## Thor Motor Coach Recall Repair Instructions

Recall #	13V-265/ 2013-217 (Canada)		
Description/Title:	RV Custom Product FW-2050 Battery Control Center		
Affected Product Line(s)	Certain Class A Units		
Service Campaign # :	RC000077	Released Date:	7/10/2013
Failure Code:	TMCRC80432V	Document Date:	7/10/2013
Time Allowed:	0.25	Document Revision:	Α

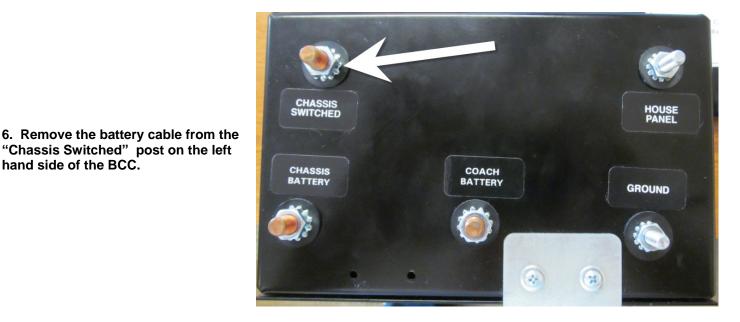
**SUMMARY:** On certain gas Class A units with the RV Custom Products FW-2050 Battery Control Center (BCC) there may be an issue with the chassis battery disconnect.

**CONCEQUENCE:** May cause loss of power to the chassis while driving causing the lights and/or other chassis components to cease functioning.

**REMEDY:** The chassis battery will no longer be disconnected with the use of the chassis disconnect switch. All other functions contained within the BCC will still operate as normal.

7. Place the cable you just removed from the "Chassis Switched" post onto the post labeled "Chassis Battery".

- 8. Tape off the "Chassis Switched" post.
- 9. Reconnect chassis battery and cable at the battery.
- 10. Inform the customer that they will need to continue to use the Chassis Disconnect Switch.
